CITY OF ALBUQUERQUE

RE: **Lot 10 Block 9 Unit 22, S.A.D. 228**
6401 Petirrojo Rd. NW
Grading and Drainage Plan
Engineers Stamp Date 5-15-17 (D10D003Q10)

DRAINAGE AND TRANSPORTATION INFORMATION SHEET

CITY OF ALBUQUERQUE, BERNALILLO COUNTY		NEW MEXICO	
LOT 10, BLOCK 9, UNIT 22 VOLCANO CLIFFS SUBDIVISION			
CANDELARIA -- COMPOS -- GRADING & DRAINAGE PLAN			
McDowell Engineering, Inc.			
7820 BEVERLY HILLS AVE. NE • ALBUQUERQUE, NM 87122 TELE: 505-828-2430 • FAX: 505-821-4857			
Designed JSM	Drawn STAFF	Checked JSM	Sheet of
File CAN0117L	Date MAY,2017	1	1

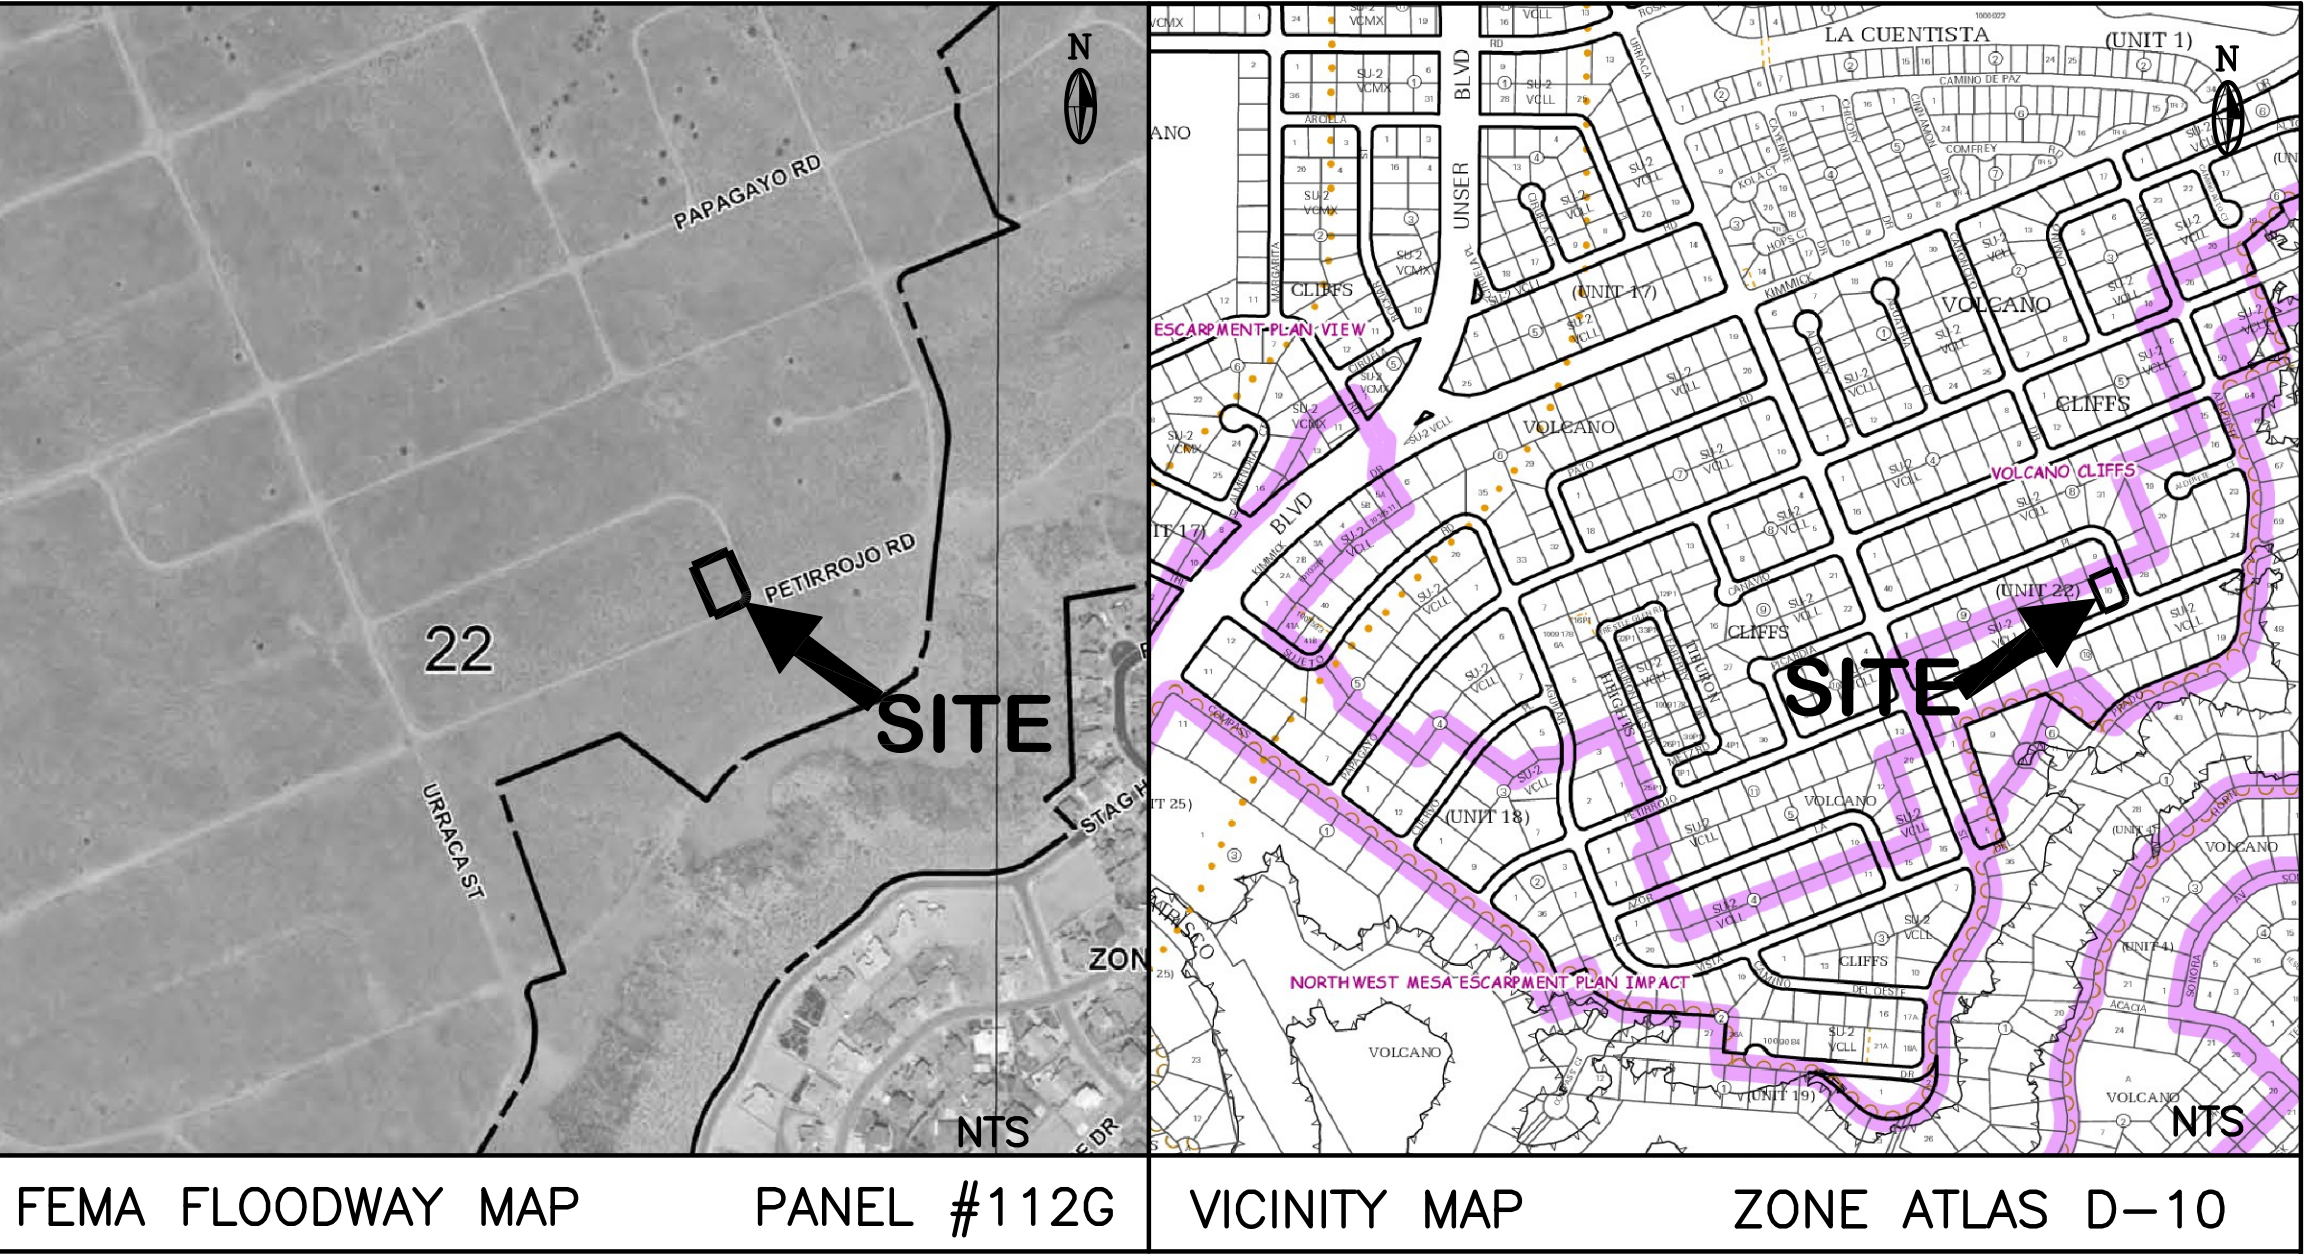
- Provide a note that this is the plan to be used for any garden wall, and that openings in the wall are placed 3" above final grade in the rear yard, to allow for cross lot drainage, heading west to east.
